City of Pembroke Pines
Planning & Economic Development Department
601 City Center Way 3rd Floor
Pembroke Pines FL, 33025

Agenda Date:	April 10, 2025	Application ID:	SP2024-0008
Project:	R L Carriers Parking Lot	Project Number:	PRJ2024-0011
Project Planner	Cole Williams, Senior Planner		
Owner:	R L R Investments LLC Greenwood Motor Lines INC	Agent:	Stan Richards
Location:	Generally located north of Johnson Street and east of northwest 209 Avenue.	Commission District	3
Existing Zoning:	PUD (Planned Unit Development)	Existing Land Use:	Industrial
Reference Applications:	N/A		
Applicant Request:	Construct a parking lot for semi-trailer truck parking and storage.		
Staff Recommendation:	Transmit to the City Commission with a favorable recommendation.		
Final:	<input type="checkbox"/> Planning & Zoning Board	<input checked="" type="checkbox"/> City Commission	
Reviewed for the Agenda:	Director: 	Assistant Director:

Re: (SP2024-0008) R+L CARRIERS PARKING LOT v5

FIRE HYDRANT DETAIL

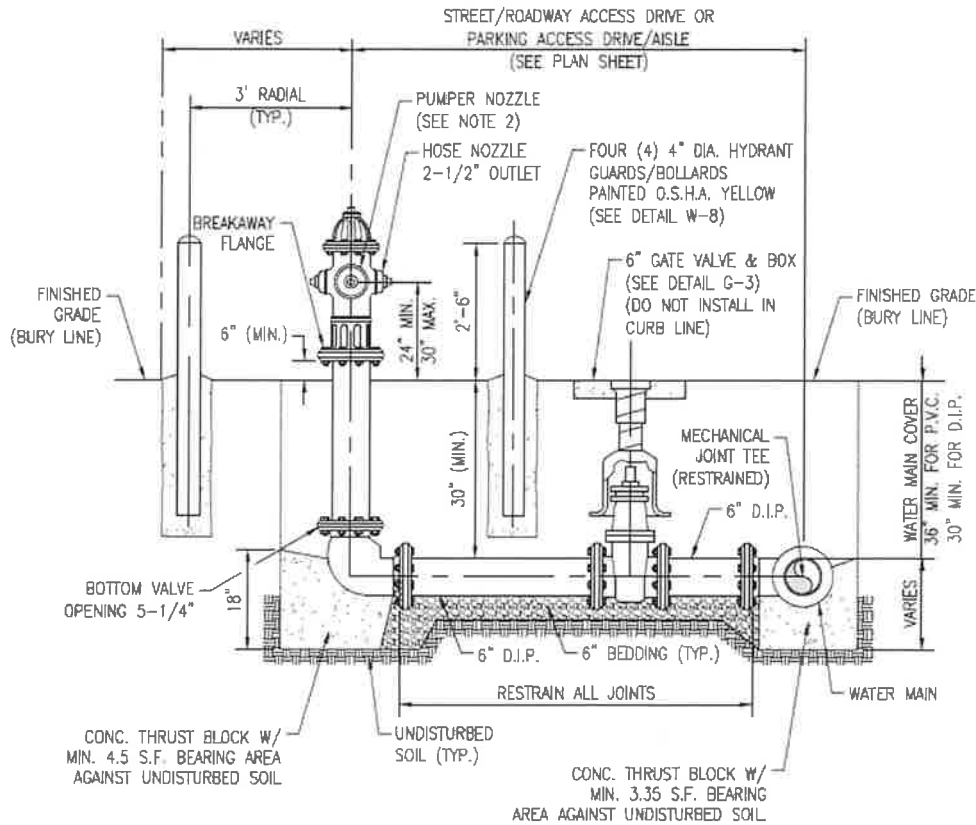
h. Fire hydrants 4 ½ inch streamer cap shall face the nearest roadway, shall be between 24 inches and 30 inches above ground, and require a blue reflector in center of roadway in front of the hydrant.

NOTE: Fire Hydrant Detail to be provided on submittal.

i. No tree, bush, hedge, or shrub, shall be planted within 15 feet diameter of a hydrant and located such that the hydrant shall be fully visible from the street. **COPP CO 93.25 (F)**

FIRE HYDRANT DETAIL

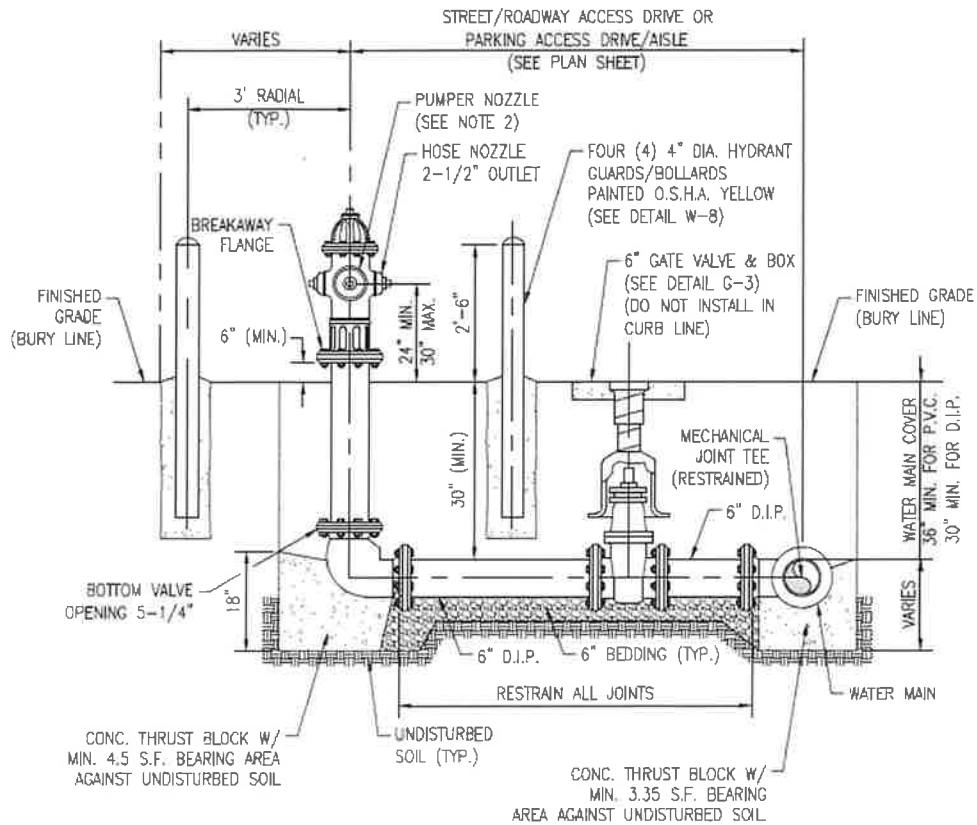
h. Fire hydrants 4 ½ inch streamer cap shall face the nearest roadway, shall be between 24 inches and 30 inches above ground, and require a blue reflector in center of roadway in front of the hydrant.

NOTE: Fire Hydrant Detail to be provided on submittal.

i. No tree, bush, hedge, or shrub, shall be planted within 15 feet diameter of a hydrant and located such that the hydrant shall be fully visible from the street. **COPP CO 93.25 (F)**

Ground Sign Assembly Details

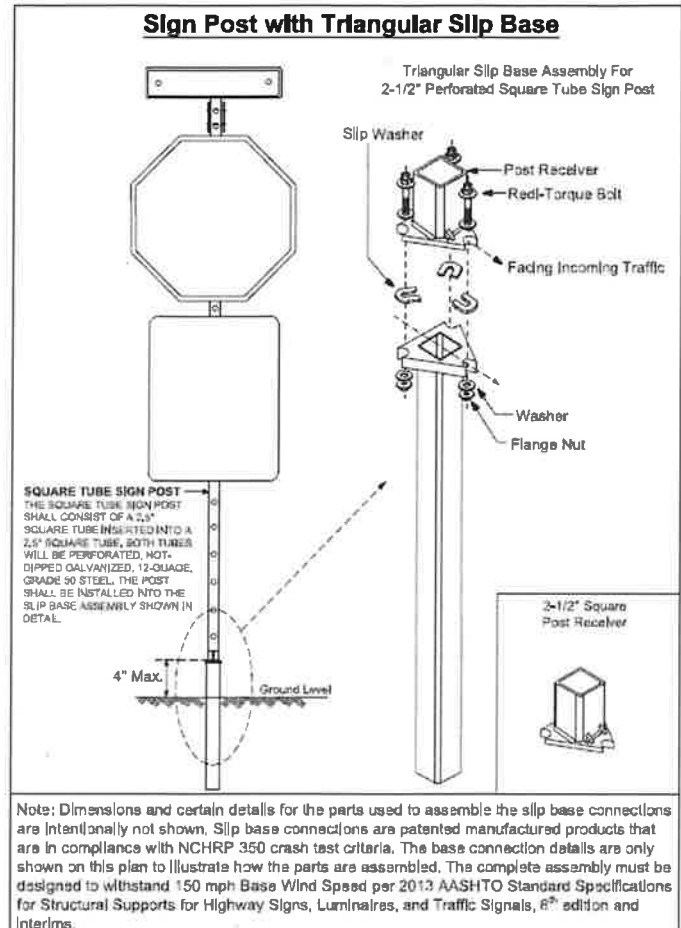
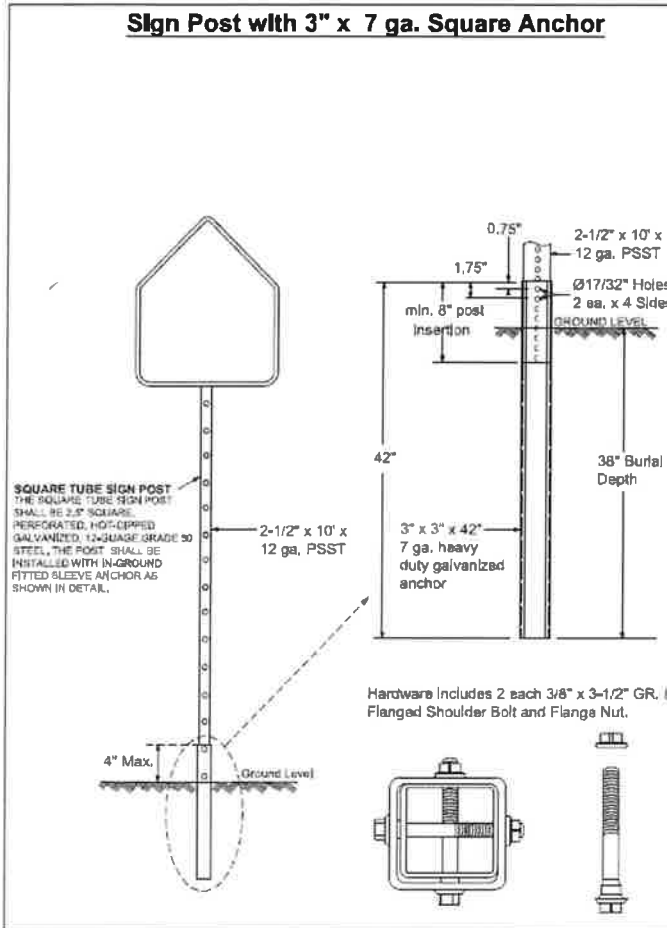
11. Place note on plan: All Support/Sign Posts Shall Conform To Current Broward County Traffic Engineering Division (BCTED) Standards For Square Tube Sign Posts With Either A Square Anchor Or Triangular Slip Base per BCTED 'Ground Sign Assembly Details'.

NOTE: Detail Provided Below
